WEBER COUNTY PLANNING DIVISION

Administrative Review Meeting Agenda

Staff Report to the Weber County Planning Division

Application Request:	Consideration, and action on a request for final approval of the Little Mountain Industrial Park Subdivision, consisting of six manufacturing lots.
Agenda Date:	Wednesday, April 22, 2026
Applicant:	Scott Carlson (Authorized Representative)
File Number:	LVL022526

LITTLE MOUNTAIN INDUSTRIAL
9175 WEST ROAD AND UTILITY DESIGN
PLAN AND PROFILE STA: 60+00 TO 65+50
WEBER COUNTY, UTAH

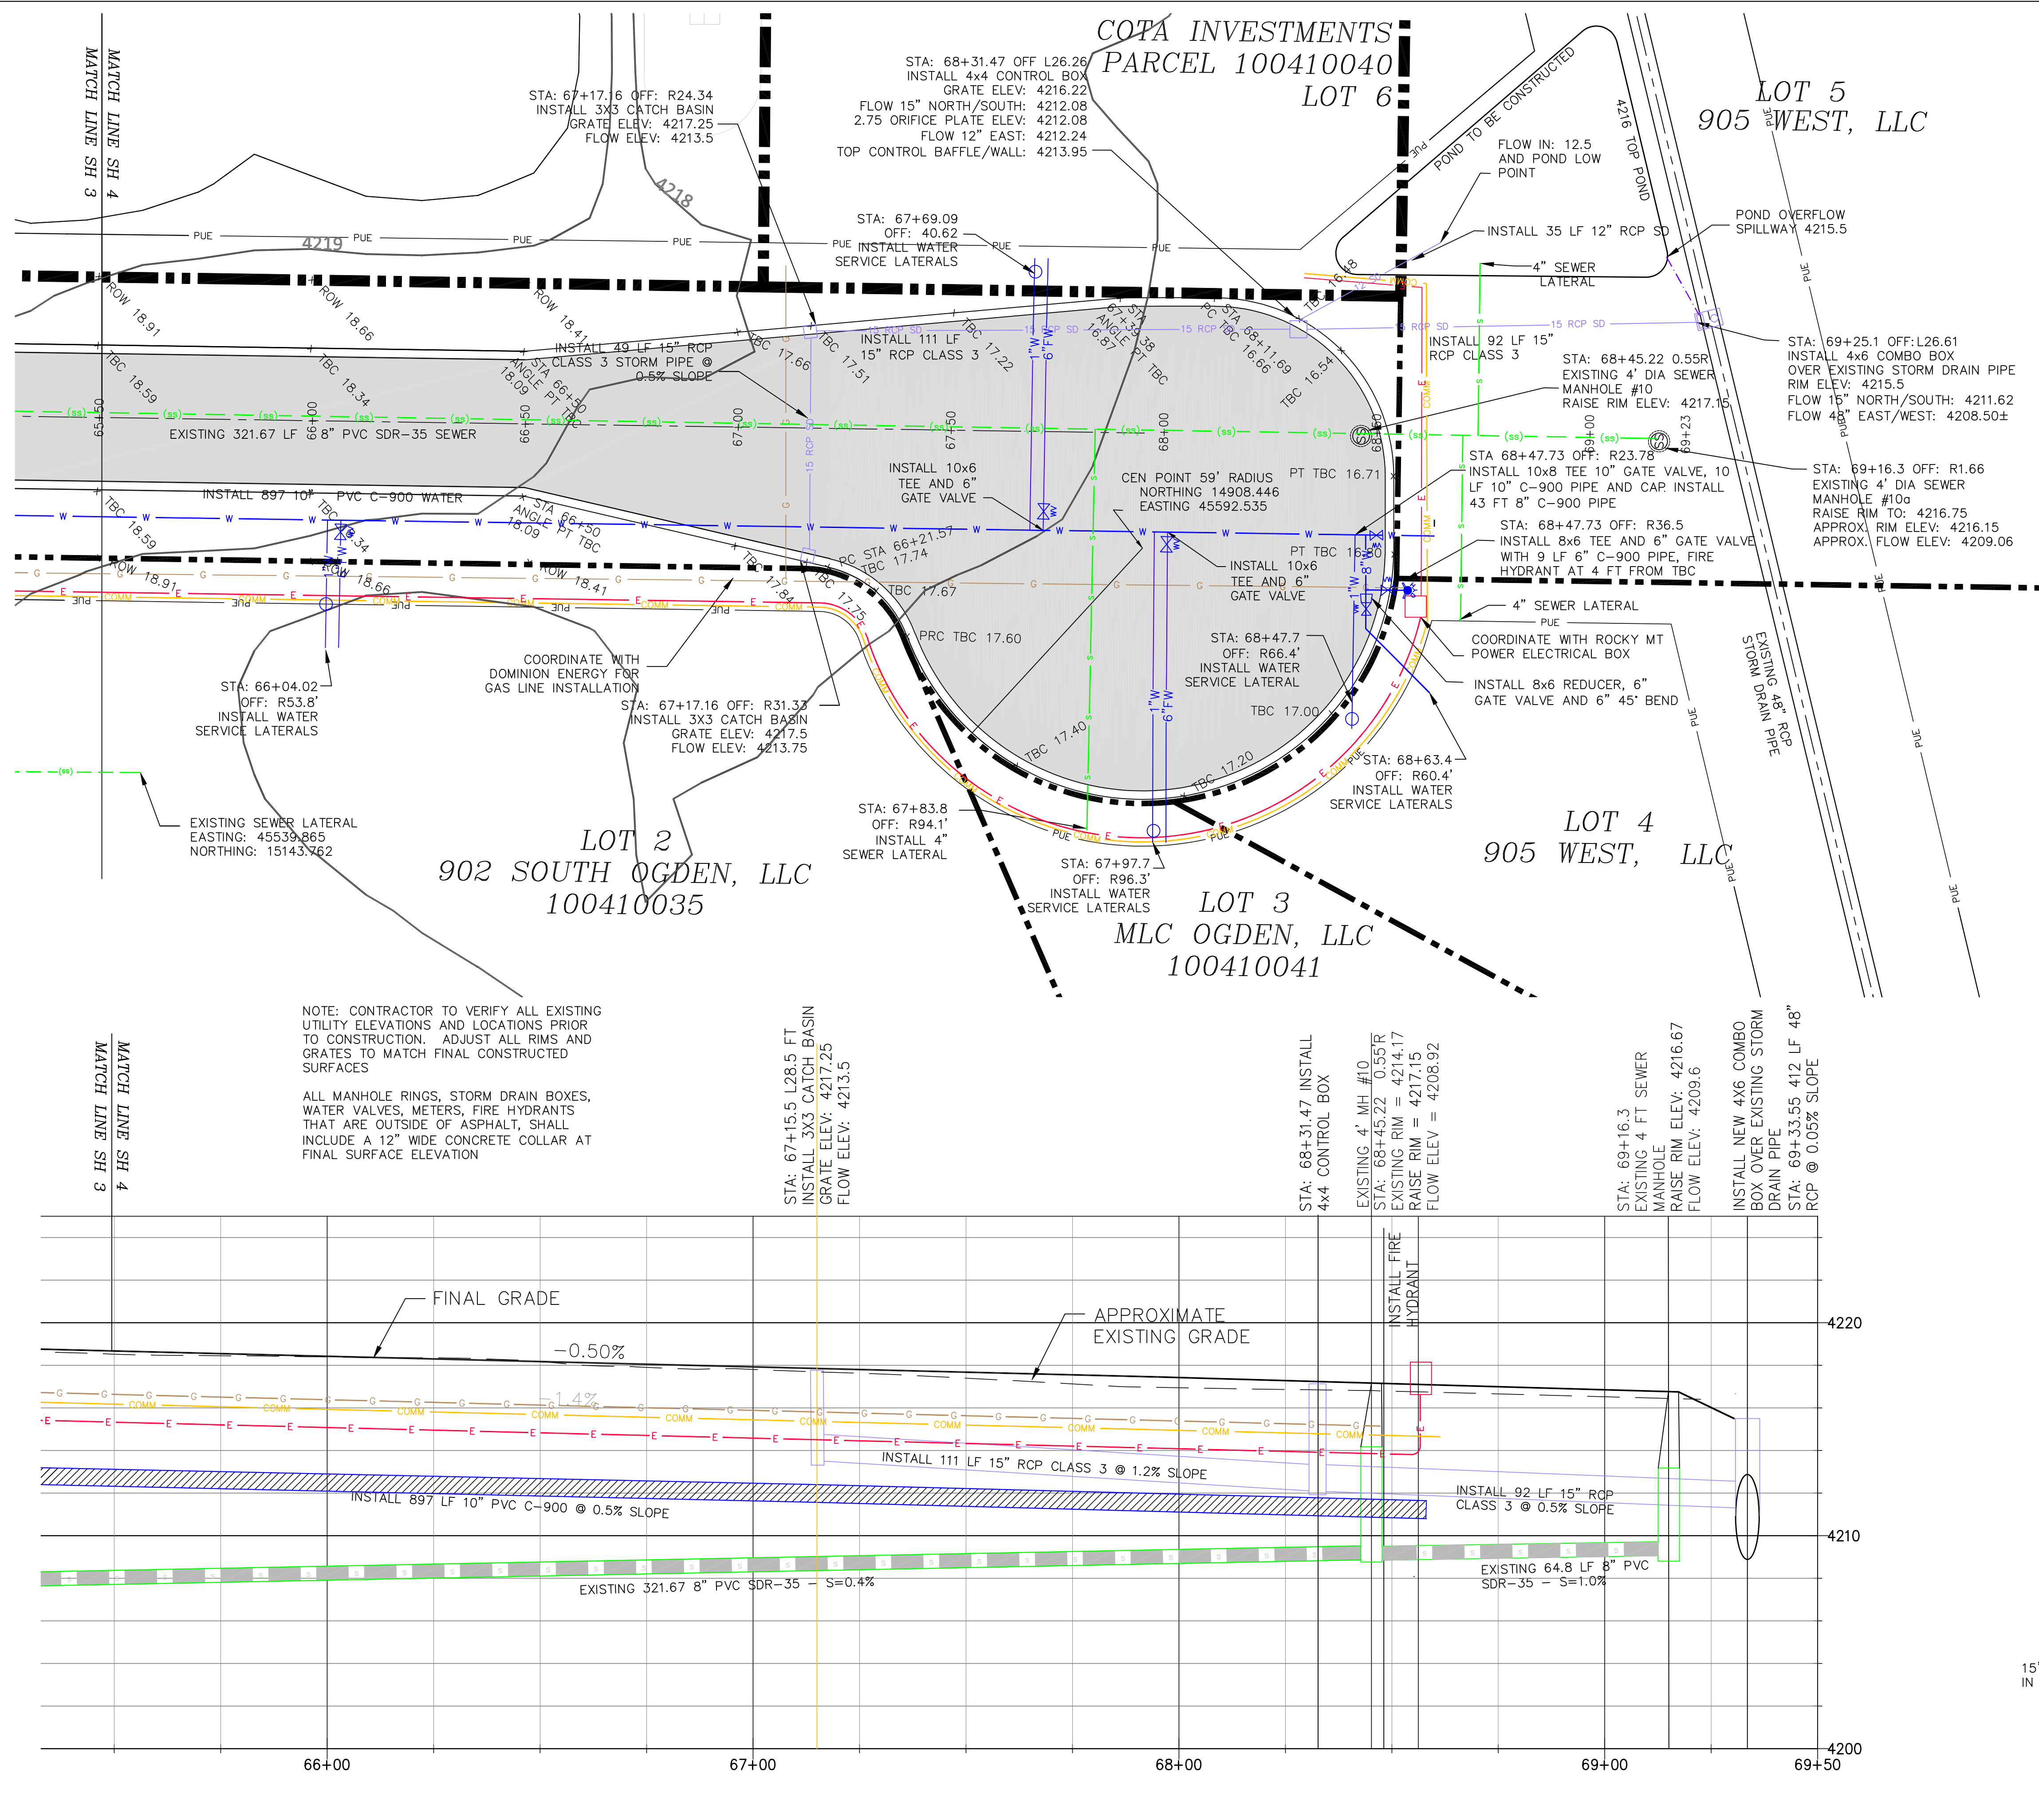
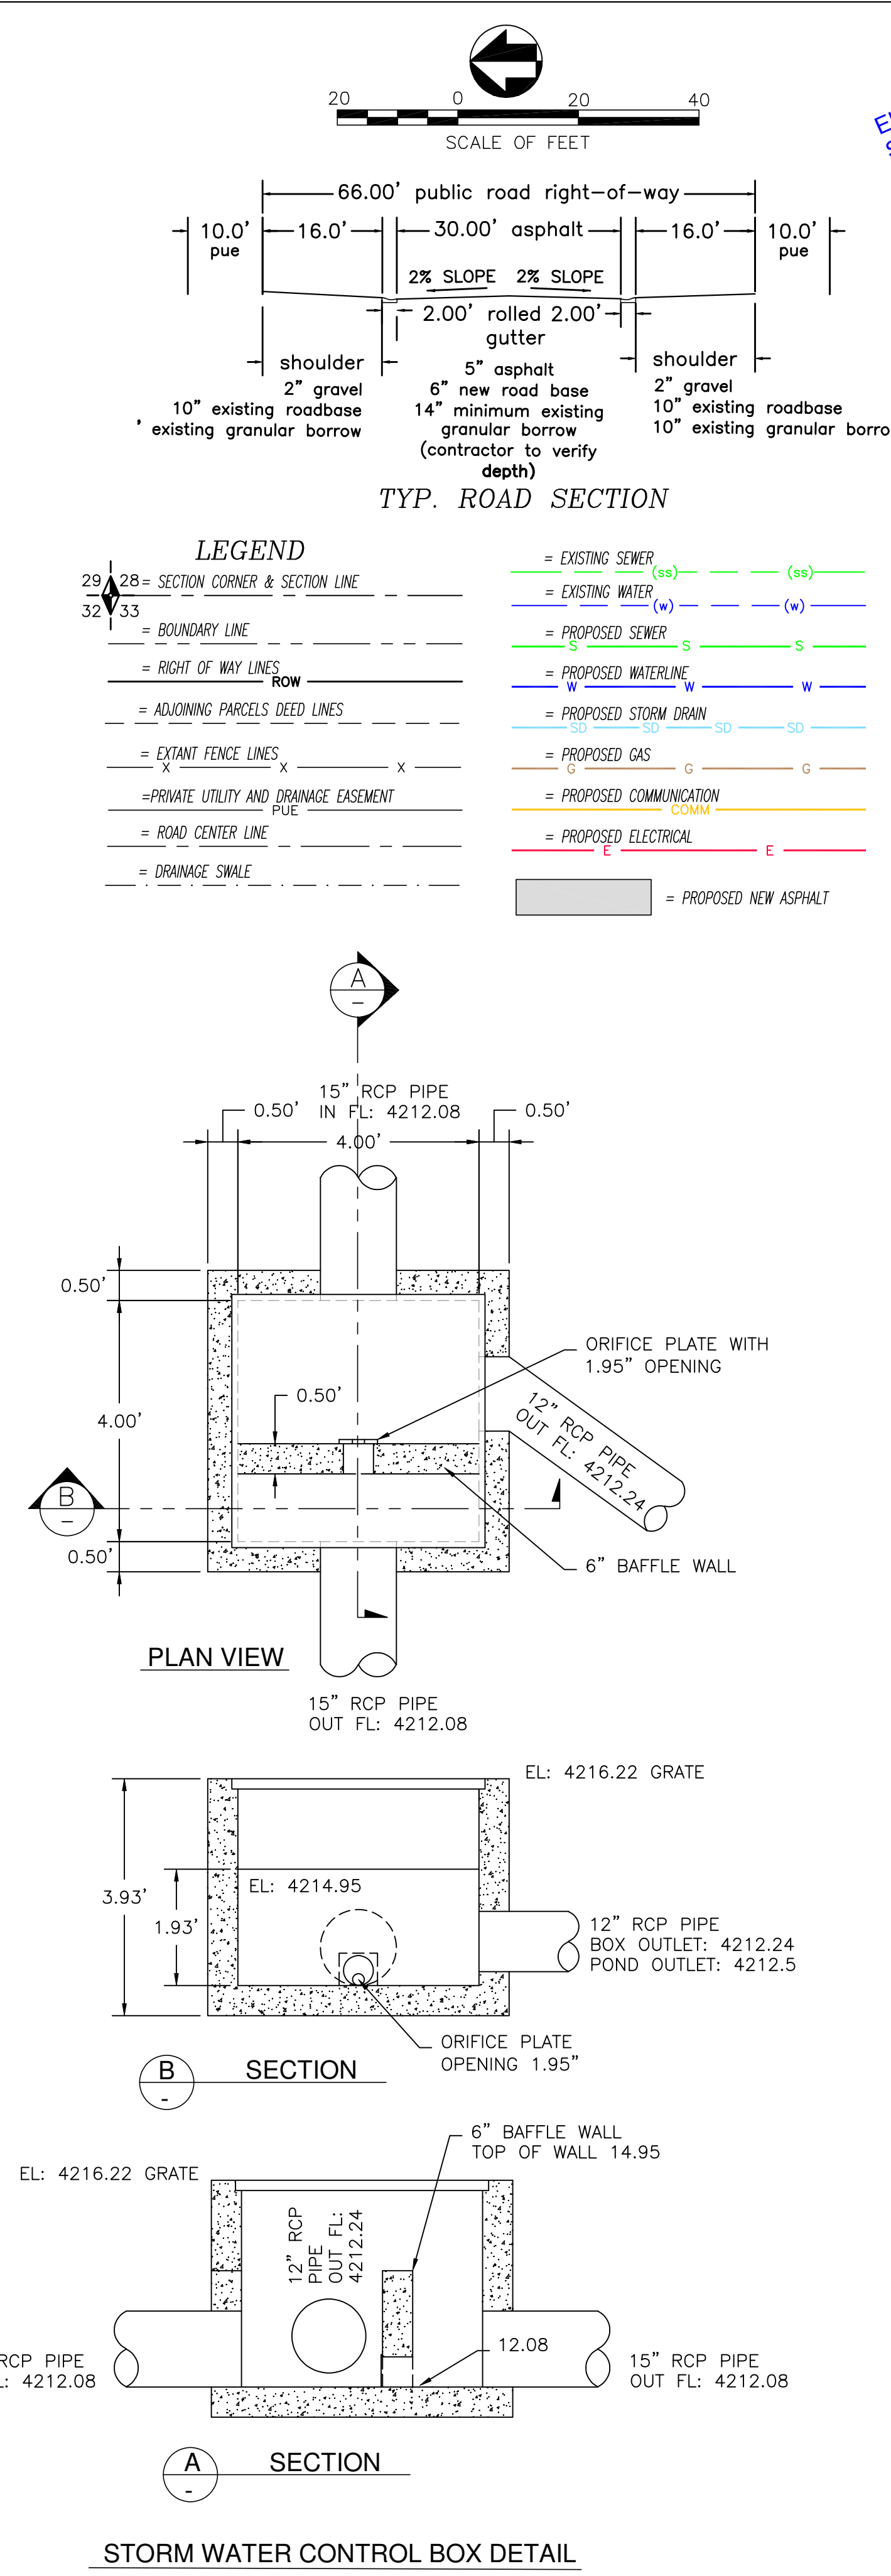
7. Sheet 4 shows an existing 8" PVC utility conduit under the proposed asphalt. This line will need to either be capped or removed to prevent any sinkholes.
